# UNITED STATES PATENT AND TRADEMARK OFFICE

APPLICATION NO.	FILING DATE	FIRST NAMED INVENTOR	ATTORNEY DOCKET NO.	CONFIRMATION NO.
10/673,333	09/30/2003	Naoto Matono	117305	2246
25944	7590	08/22/2005	EXAMINER	
OLIFF & BERRIDGE, PLC P.O. BOX 19928 ALEXANDRIA, VA 22320			HEINZ, ALLEN J	
		ART UNIT		PAPER NUMBER
		2653

<b>Office Action Summary</b>	Application No.	Applicant(s)
	10/673,333	MATONO ET AL.
	Examiner	Art Unit
	A. J. HEINZ	2653

Addendum A

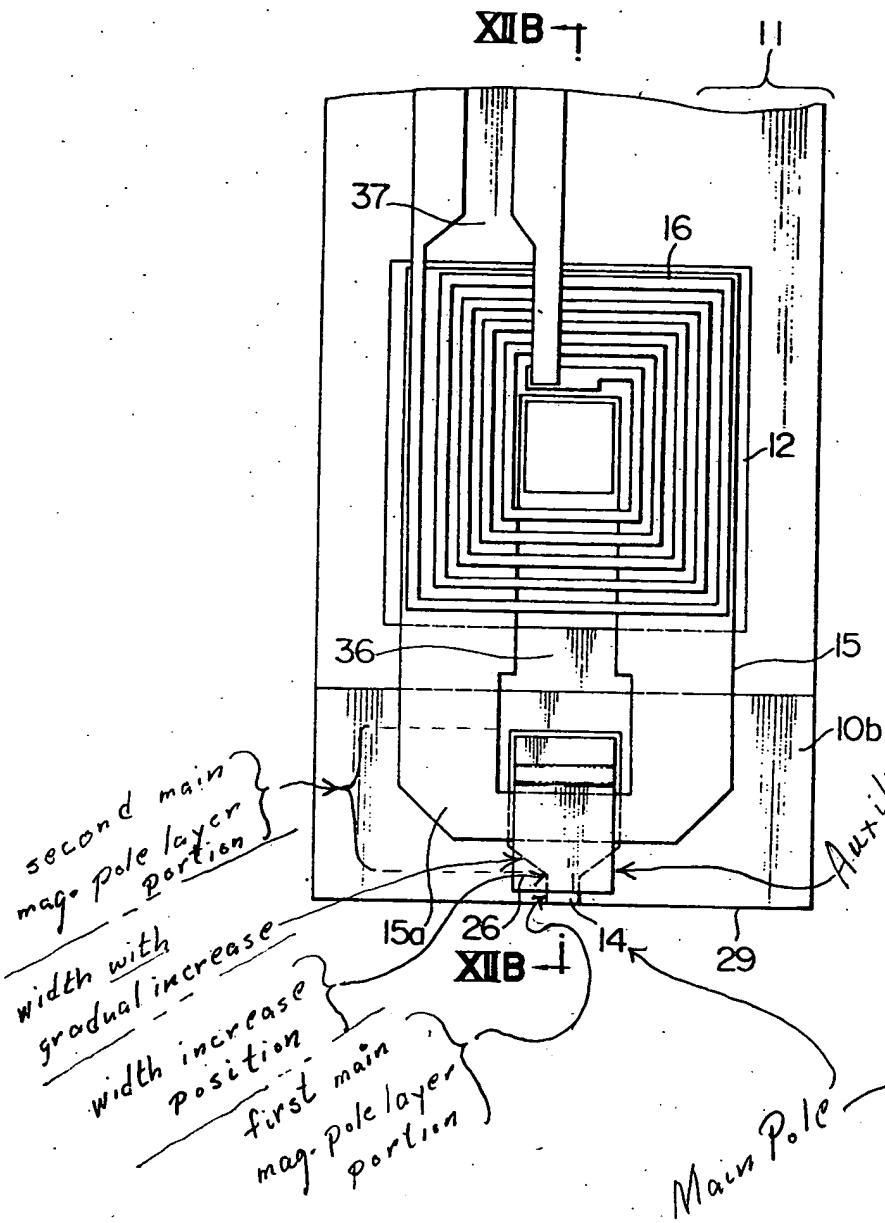
5. Claims 10,14&15 are rejected under 35 U.S.C. §102(b) as being anticipated by Nakamura.

See Figs. 12a&b. Note, to the extent claimed and understood, the structure as shown in Addendum A reads on and performs to the same degree as claimed.
